TCO # 002133
DATE February 06, 1984
FINAL PRODUCT MANUFACTURED BY
PLANT # 0093/0052
PLANT TCO # 1BP# 724

BULLETIN NO.: 12/16B:1

PRODUCT: 26-4004/5 (Model 12)

SUBASSEMBLY: Motorola Video Board

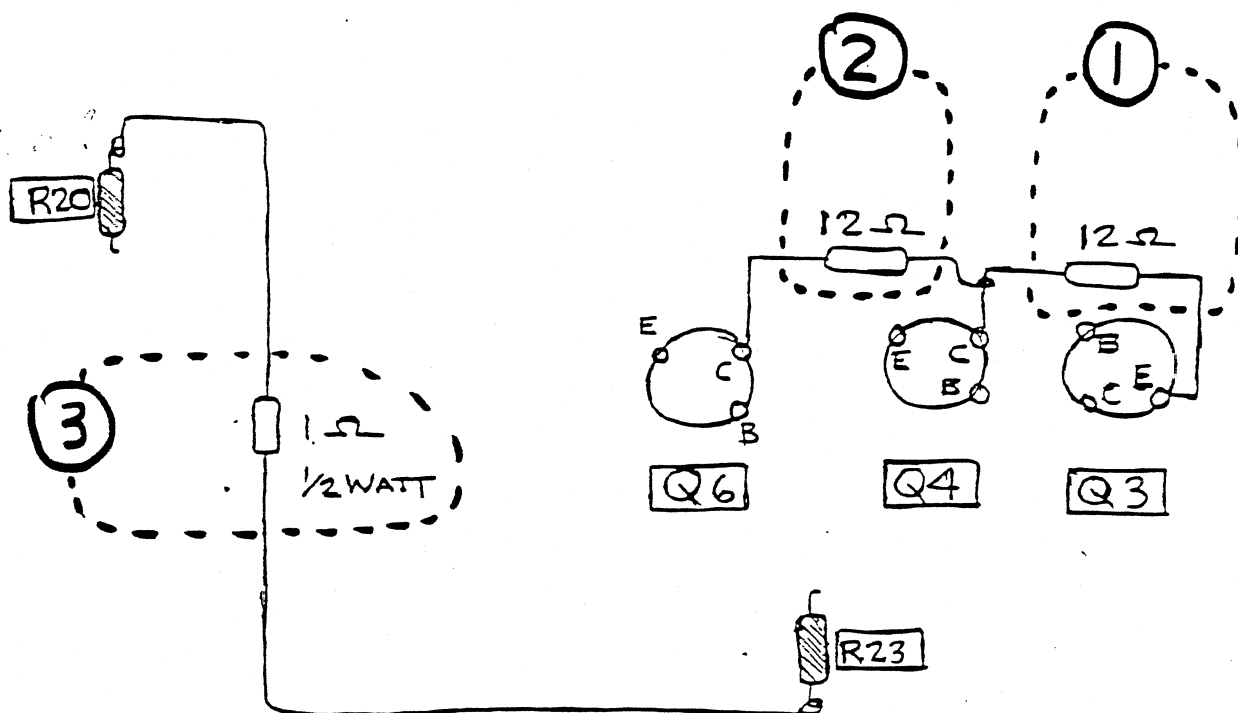
The optimum values of each of the above are 10 ohm, 10 ohm and .33 ohm respectively. Attached is a pictorial that shows how to correct these values on top side of PCB.

Improper values in any of these locations causes the supply not to be able to come up under certain conditions - notably, high current drain, low line (or in some cases even high line) and cold power supply.

24 FIX (TO CHANGE FROM .47 TO .33)

19 FIX (TO CHANGE FROM 47 TO 10)

18 FIX (TO CHANGE FROM 56 TO 10)

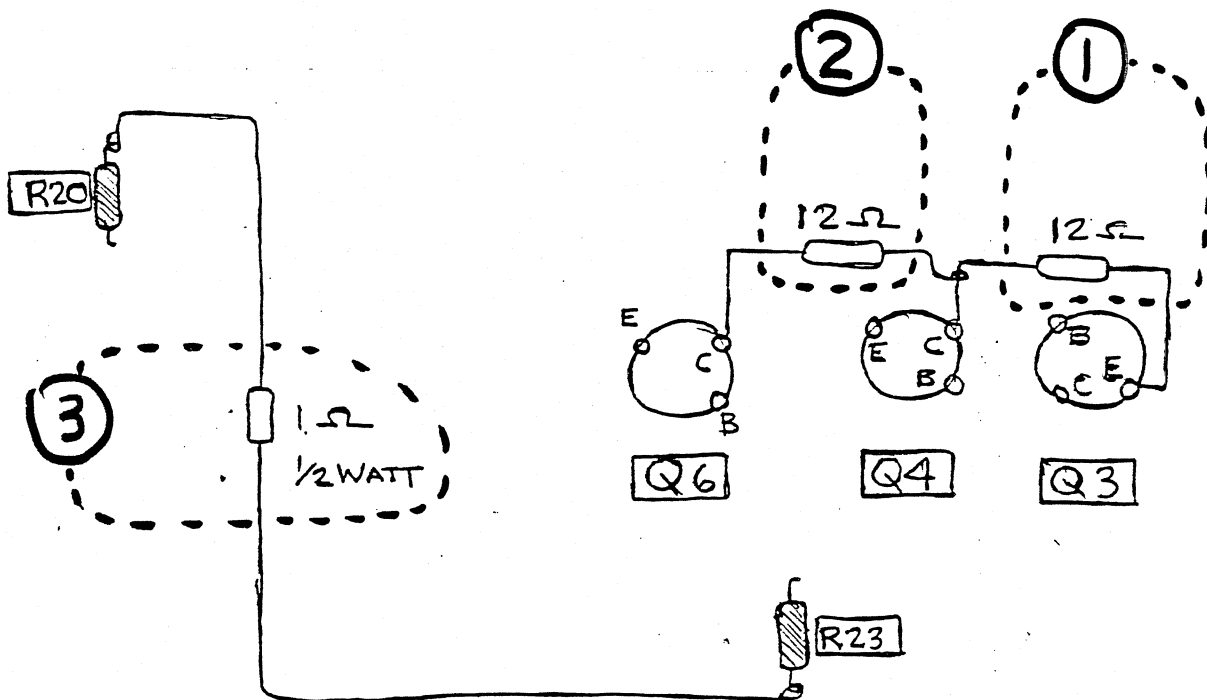
Change value of R18 from 56 ohms to 10 ohms.

Change value of	Description of change
	To do this without removing PCB, connect a 12 ohms resistor from emitter of Q3 to collector of Q4.
	See sketch.

R24 FIX (TO CHANGE FROM 47 TO .33)

R19 FIX (TO CHANGE FROM 47 TO 10)

R18 FIX (TO CHANGE FROM 56 TO 10)

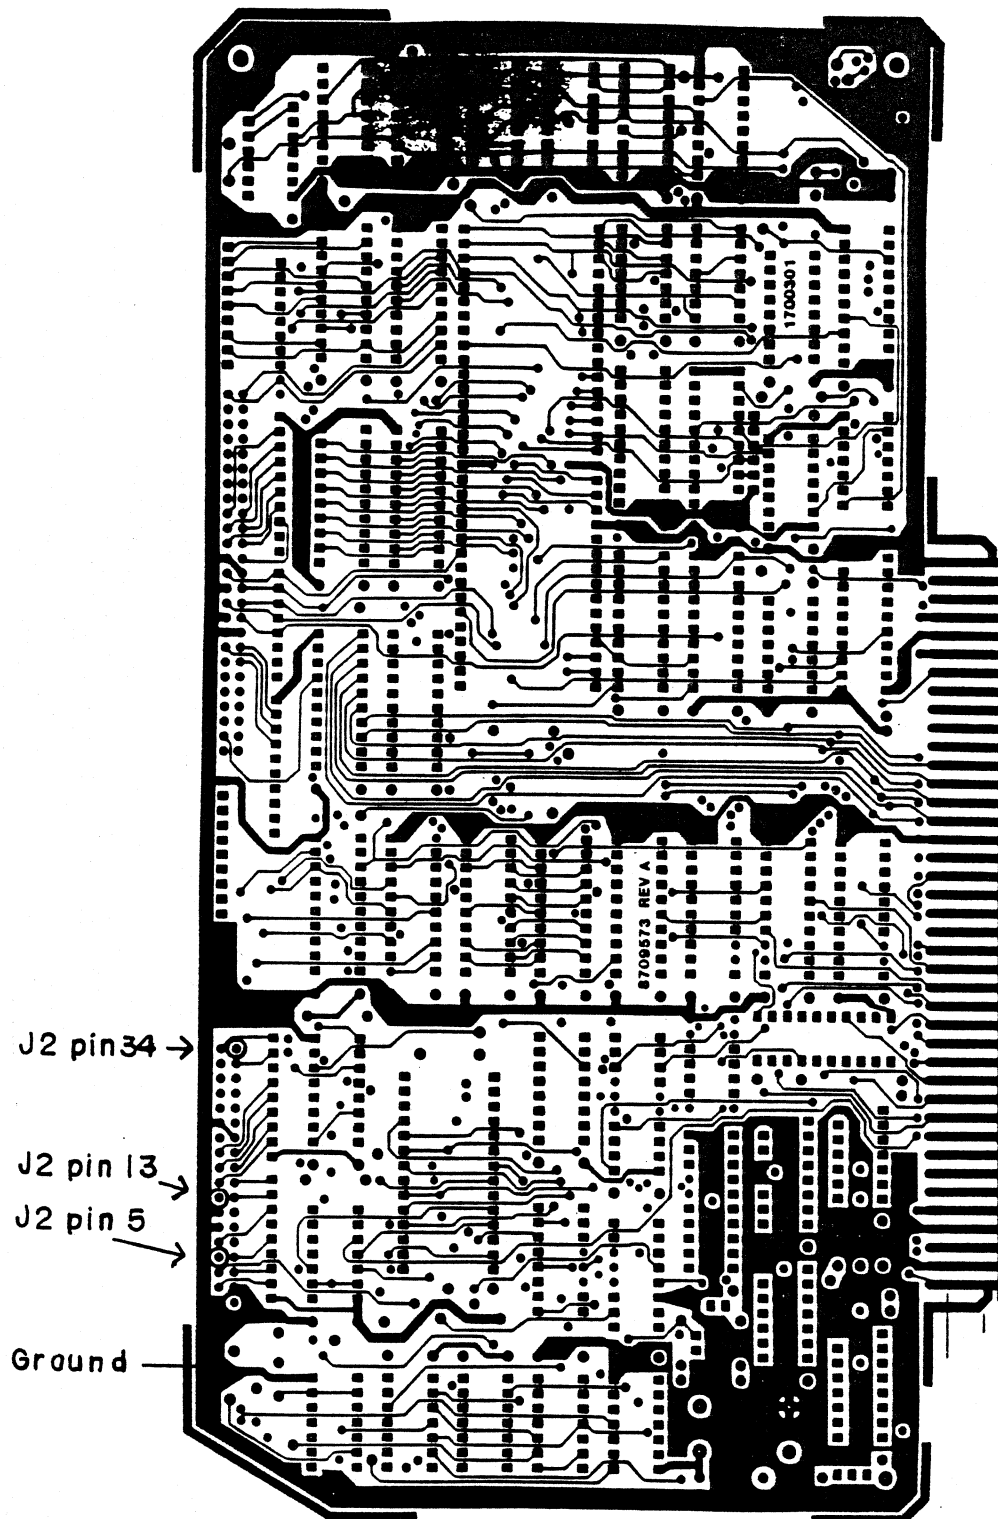
Due to an error in the artwork on early revision (Revision A) boards, a modification to insure good ground connections between the 68000 CPU board and associated memory boards is required.

Ground may be found at the feed-throughs on the ground plane near J2 on the solder side on the board.

Figure 1

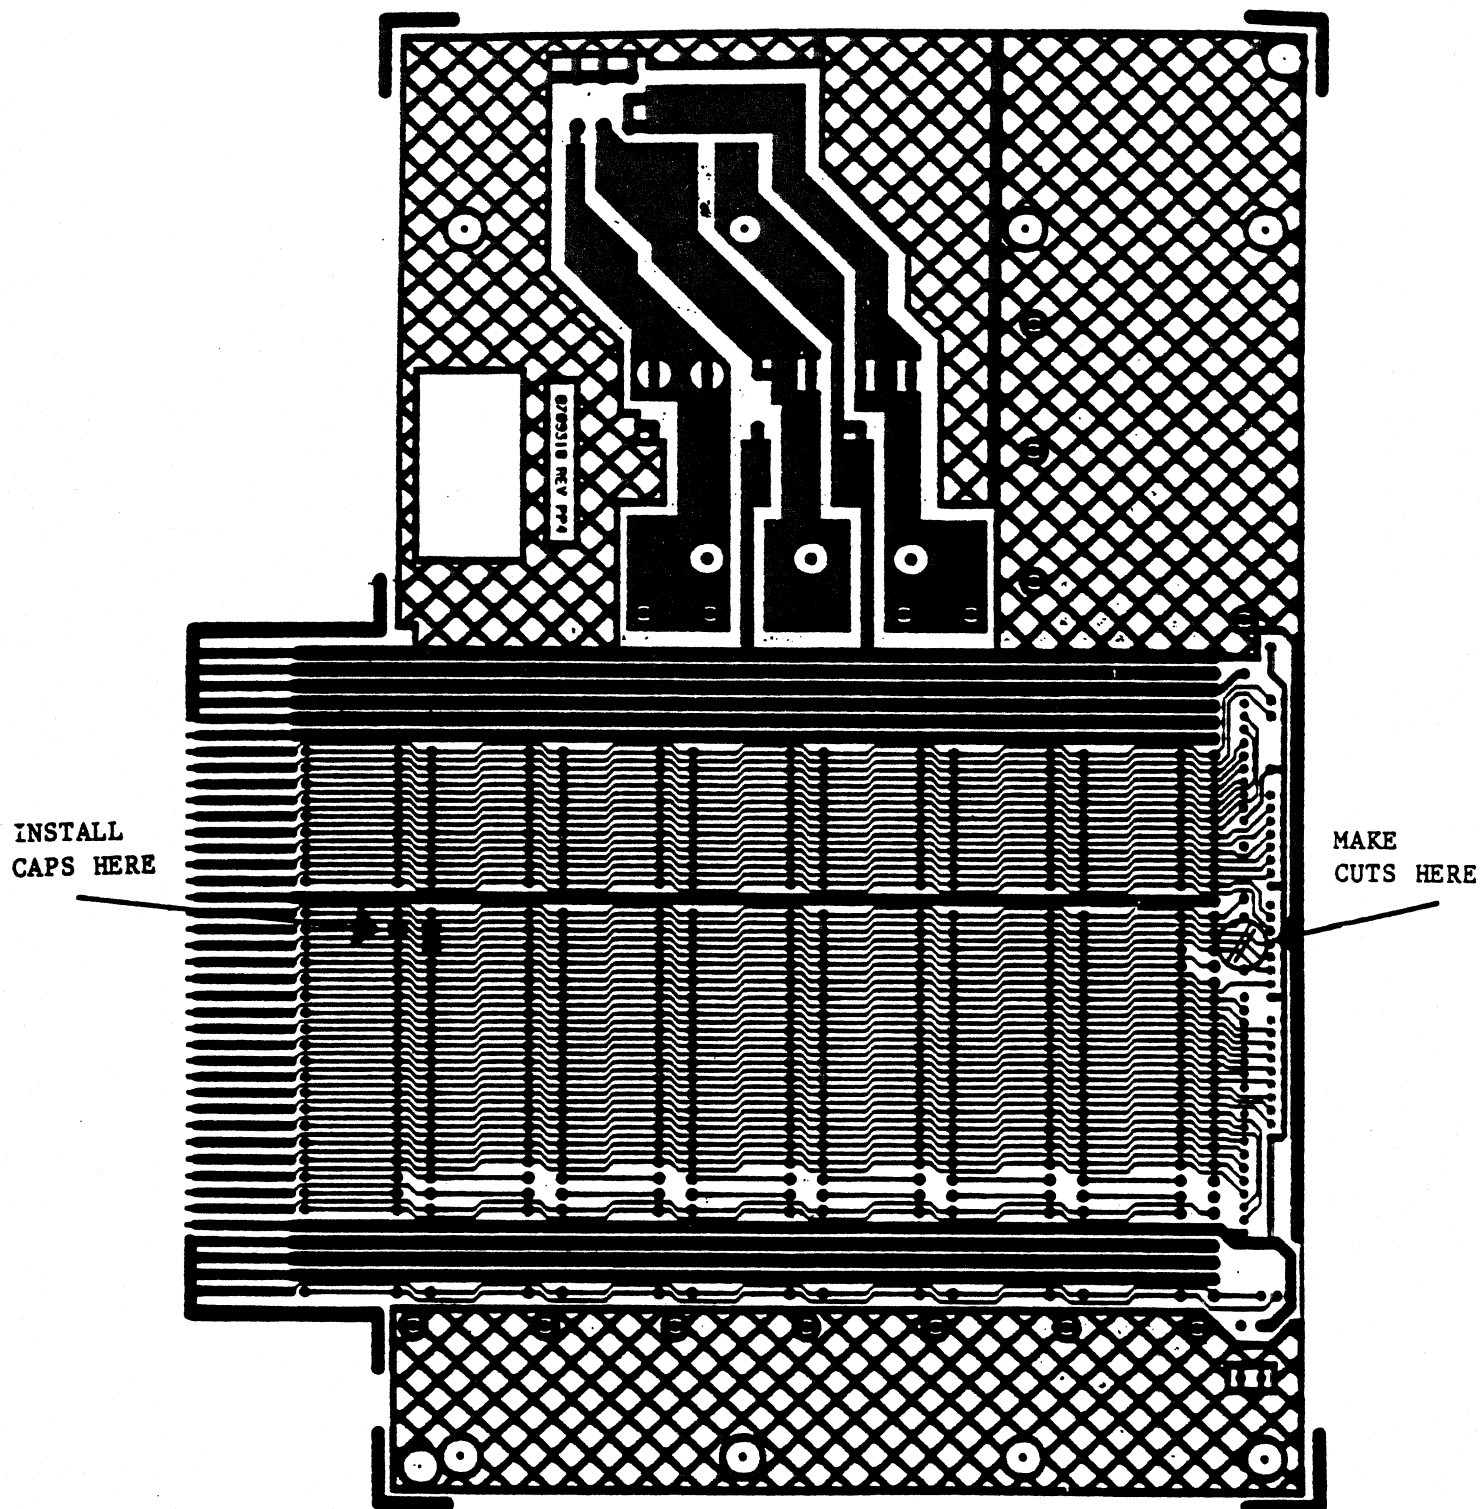
Due to a change in the silk-screening for the resistor packs on the card cage mother board, the actual pin to be cut on the resistor packs will be different for certain board revision levels.

On mother boards of revision levels prior to Rev. B, pins 3, 4, and 5 on resistor pack R6 need to be cut.

On mother boards of revision level Rev. B or later, pins 4, 5, and 6 on resistor pack R6 need to be cut.

On boards of all revision levels, three (3) 220 pf caps should be jumpered from pins 44, 45, and 46 to ground on the bottom-most connector. These pins correspond to the traces cut on the resistor pack R6. See Figure 1 for clarification. The capacitors needed for this modification may be ordered as:
